Change Order

Edward Devotion School Project
Town of Brookline
333 Washington Street
Brookline, MA 02245

CHANGE ORDER NUMBER: 016

(Include, where applicable, any undisputed amount attributable to previously executed Construction Change Directives)
CR009 Fill Voids Under 1913 Building SOG \$5,865; CR089 PR #15R1 - Extended Slab at K-2 Wall Footing \$3,398; CR093
PR #73 - LGMF Back-up Wall in Large Gym \$20,542; CR117 PR #85 - Shadow Box at CW28 and Added Gyp Soffit \$2,388;
CR131 Replacement of Bird Screens at Cupola per HMFH Field Report \$966; CR136 RFI #368 - Added Wall in MDF 109
\$2,434

**8 SECTION**  
1/2" = 1'-0"

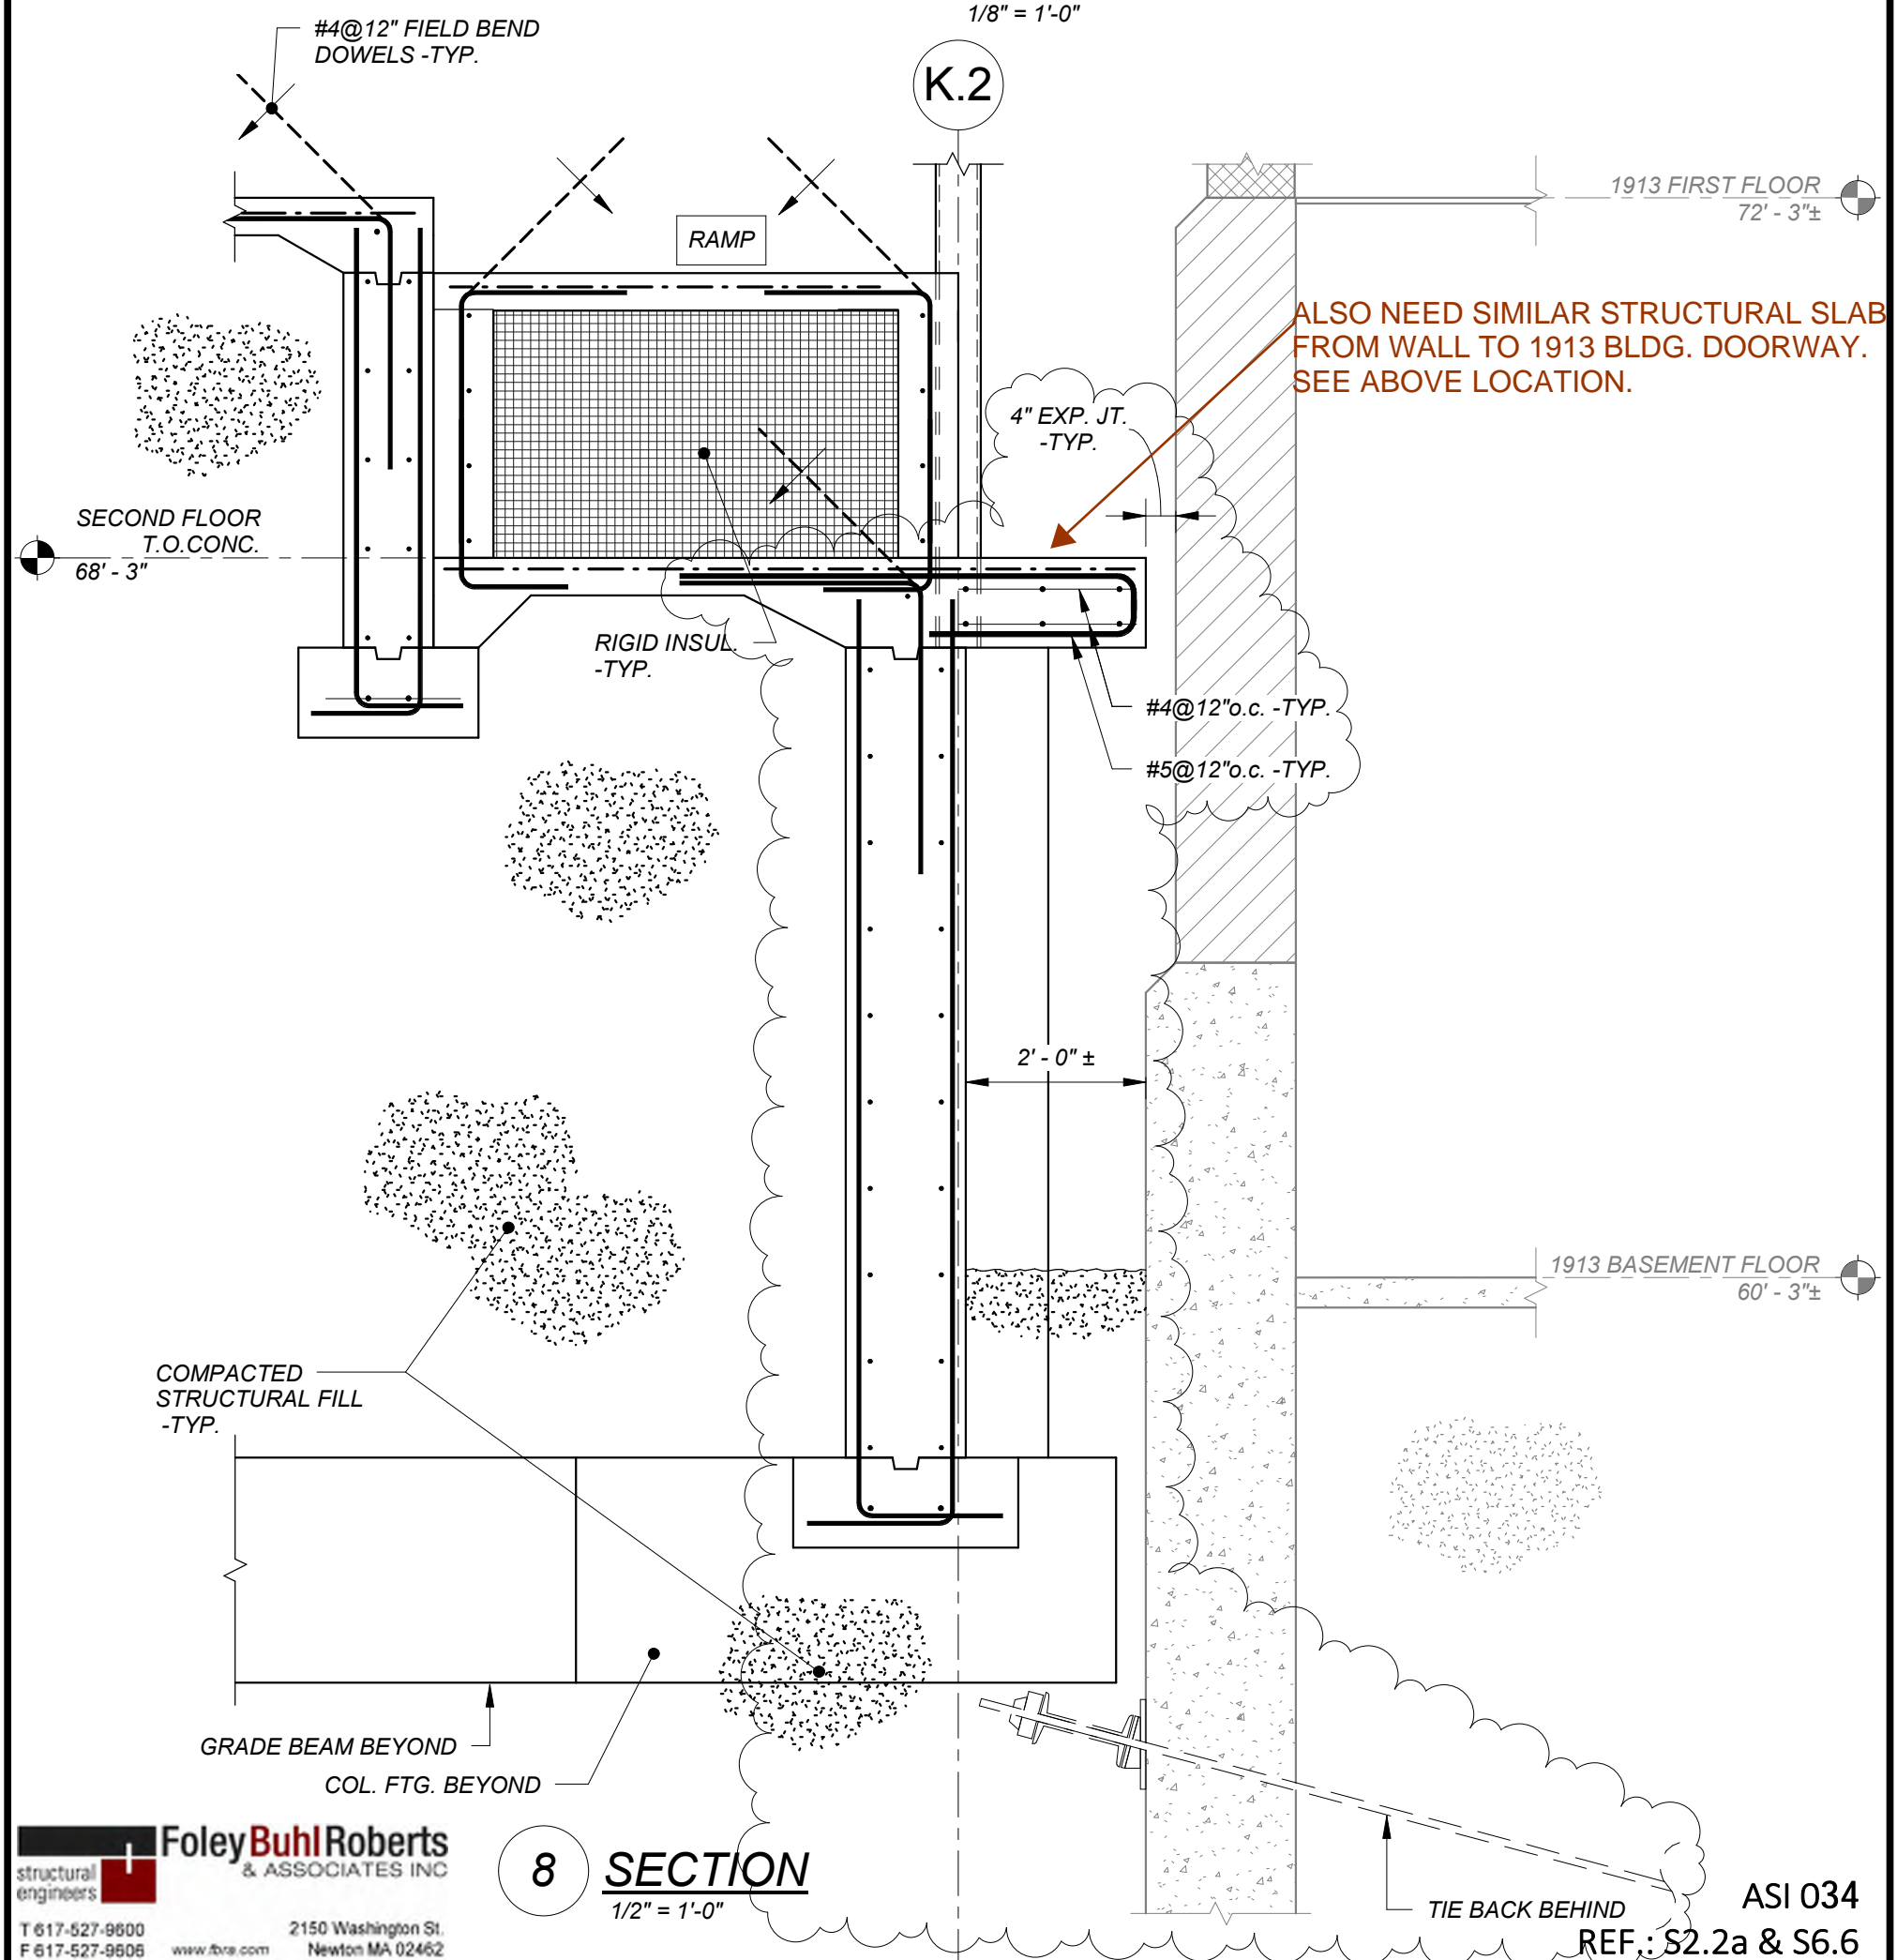
The top tier tieback wale on the south side of the 1913 building is in conflict with the proposed wall footing along column line K.2. See attached sketch.  
Please advise if the K.2 wall footing at B/Ftg EL. 55'-2 1/2" can be raised 1' to EL. 56'-2 1/2". This would put the bottom of the wall footing approximately 8" above the wale.

REVISED 12/20/2016 RESPONSE:  
PLEASE REFER TO THE ATTACHED SKS-121.

**SKA  
362**

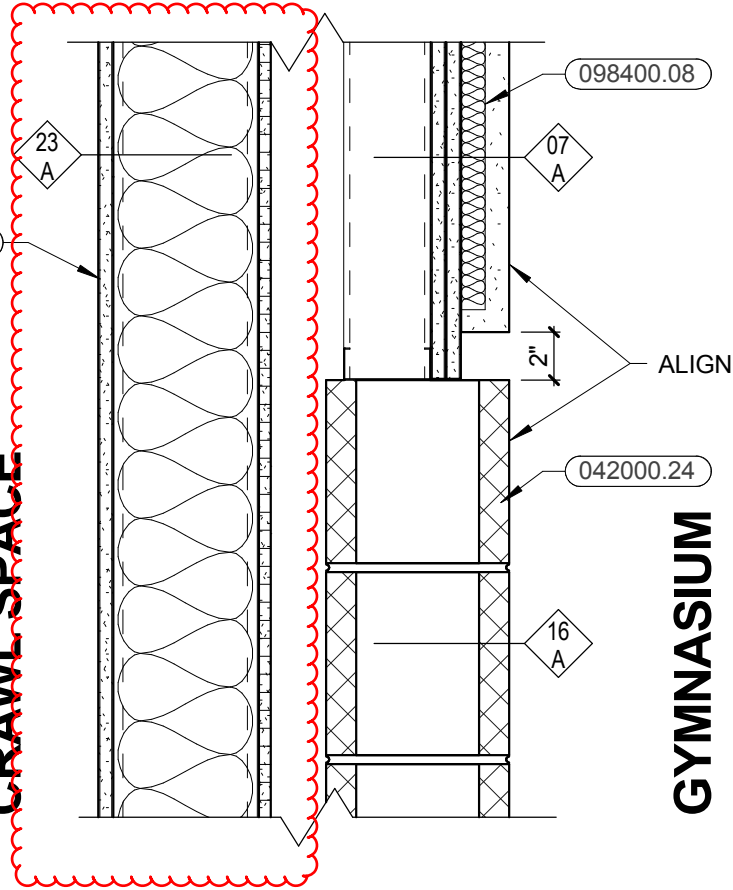
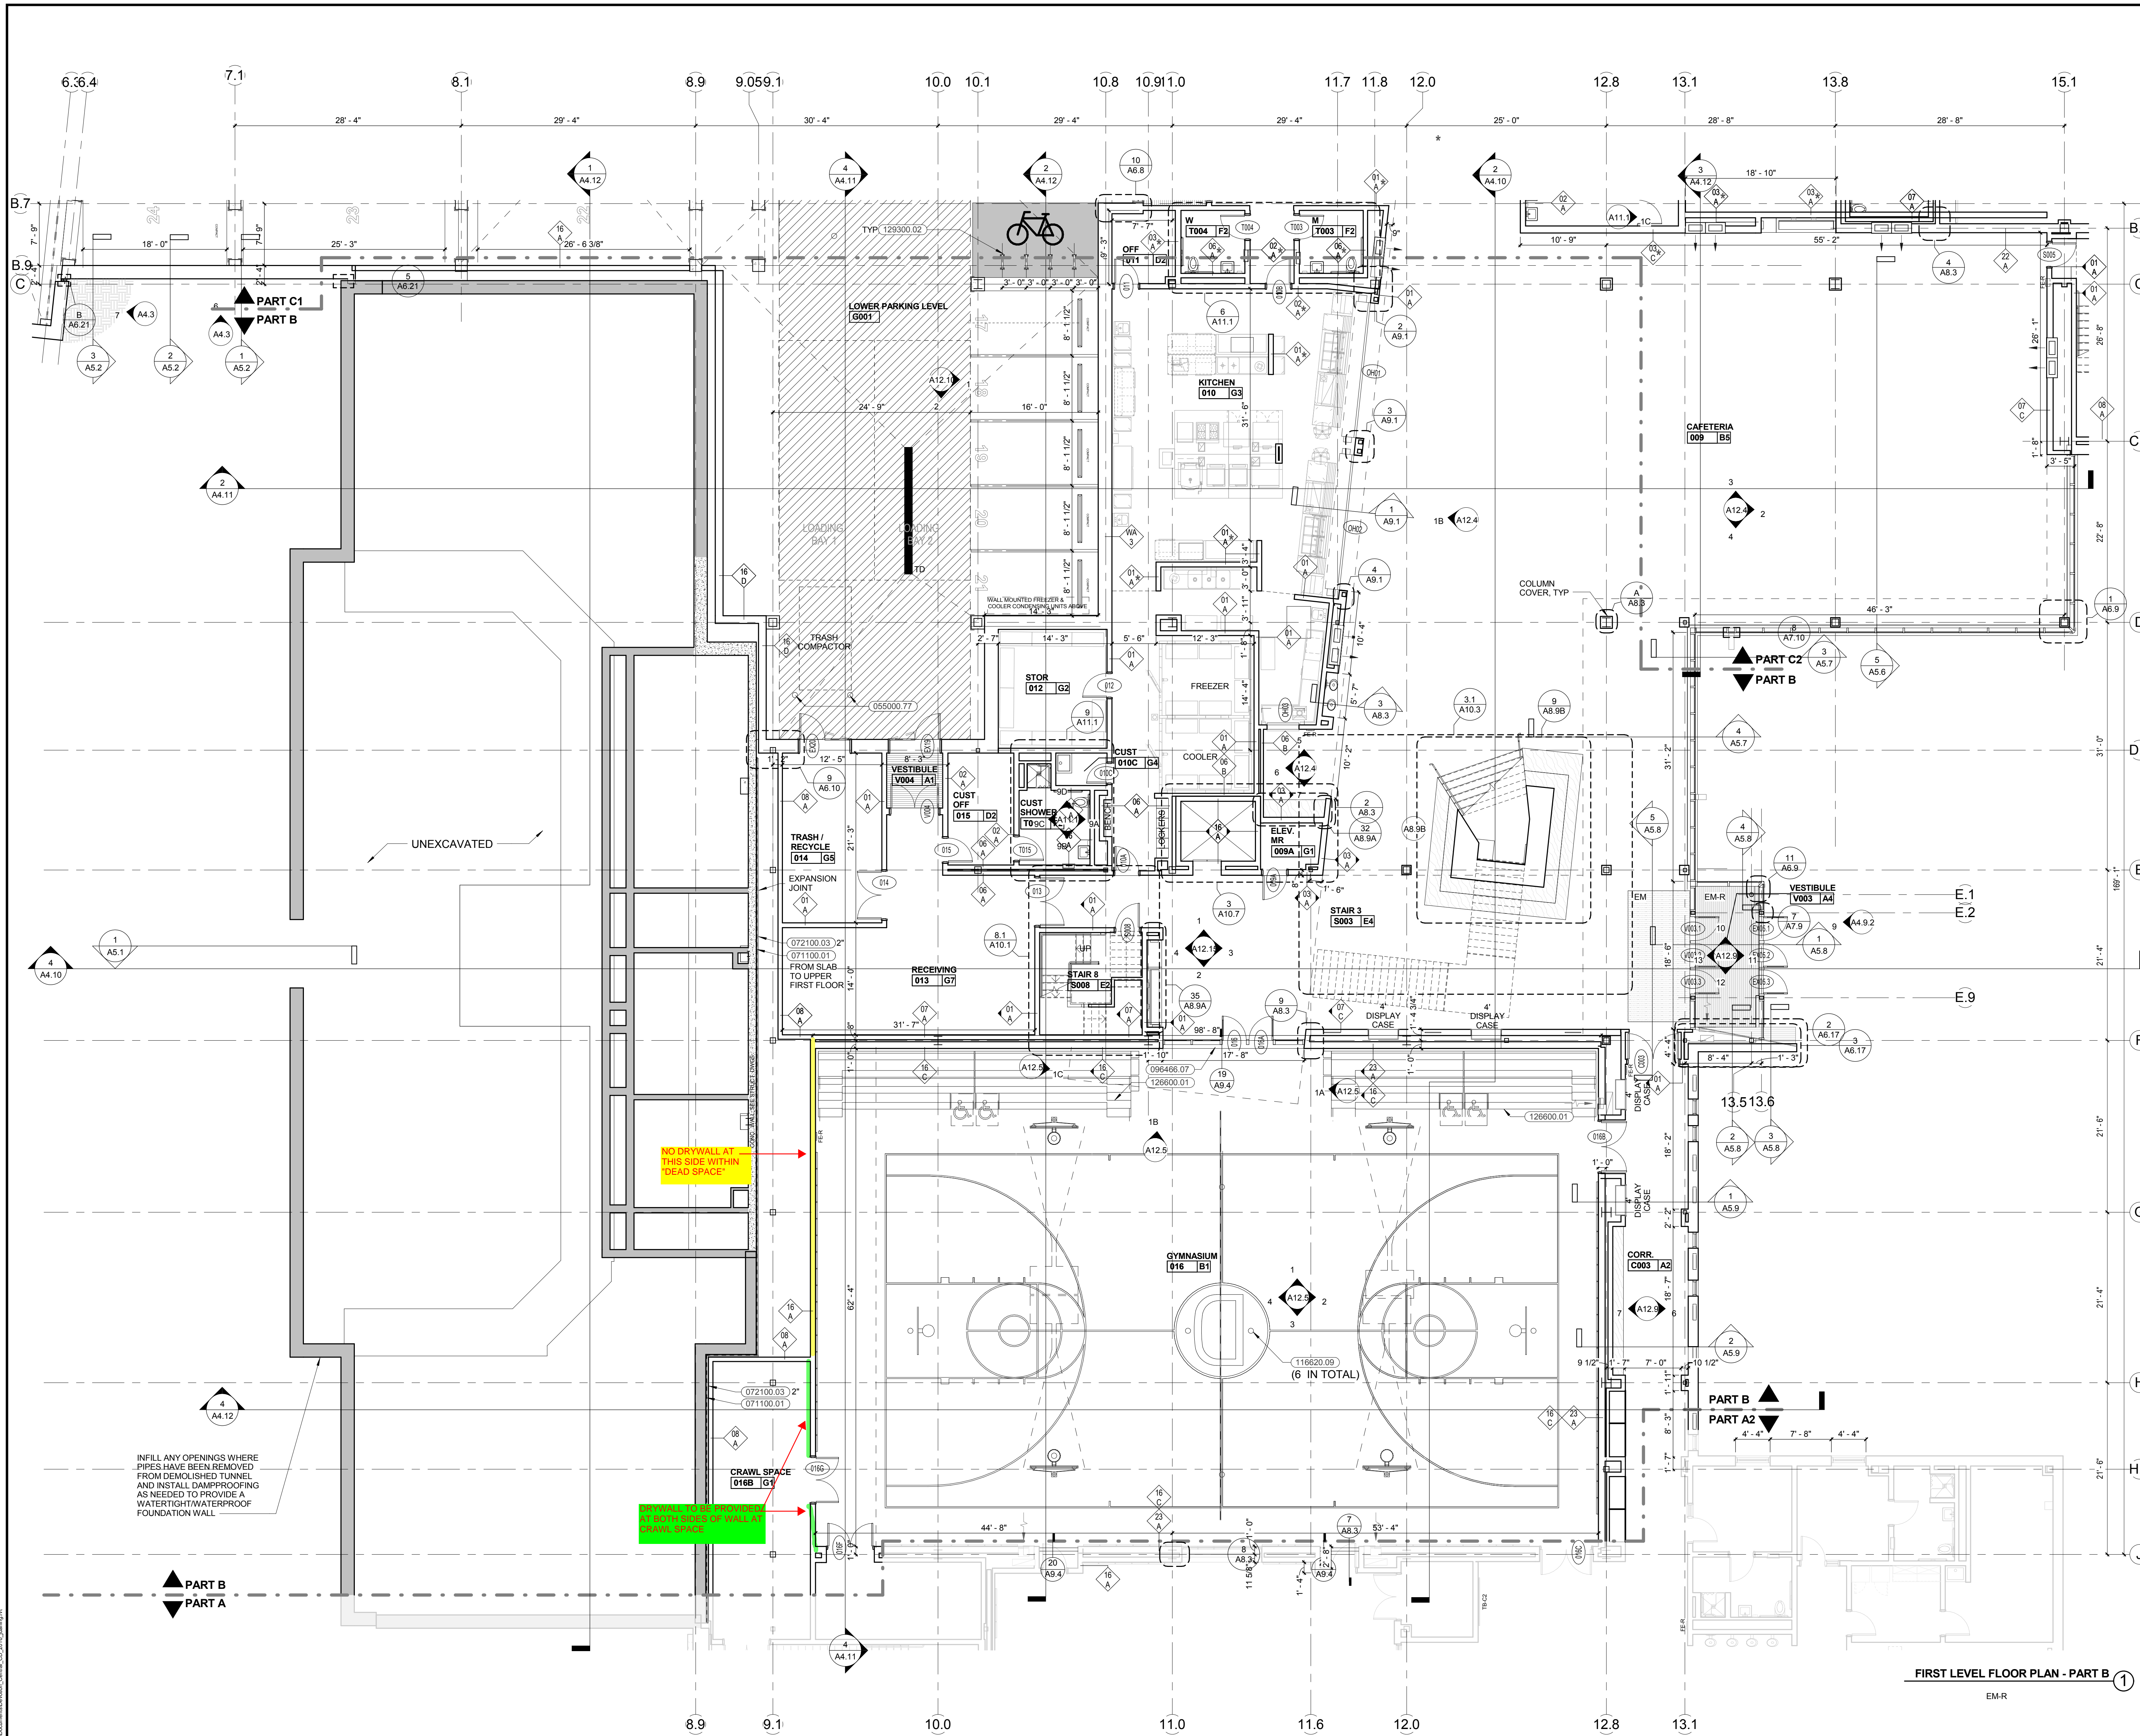
<b>Proposal Request Description:</b>
Please submit an itemized proposal for changes in the Contract Sum and Contract Time for proposed modifications to the Contract Documents described herein.
<b>THIS IS NOT A CHANGE ORDER, A CONSTRUCTION CHANGE DIRECTIVE OR A DIRECTION TO PROCEED WITH THE WORK DESCRIBED IN THE PROPOSED MODIFICATIONS.</b>
Refer to attached SKA-362: The west wall of the Large Gymnasium is to have LGMF backup wall similar to the other 3 gym walls. Provide appropriately sized studs for L/600 deflection with a 5 PSF design pressure. Refer to comments of light gauge submittal 054000-29. This proposal request is a result of RFI 354R1.

AT CRAWL SPACE, PROVIDE  
DRYWALL AT INSIDE FACE
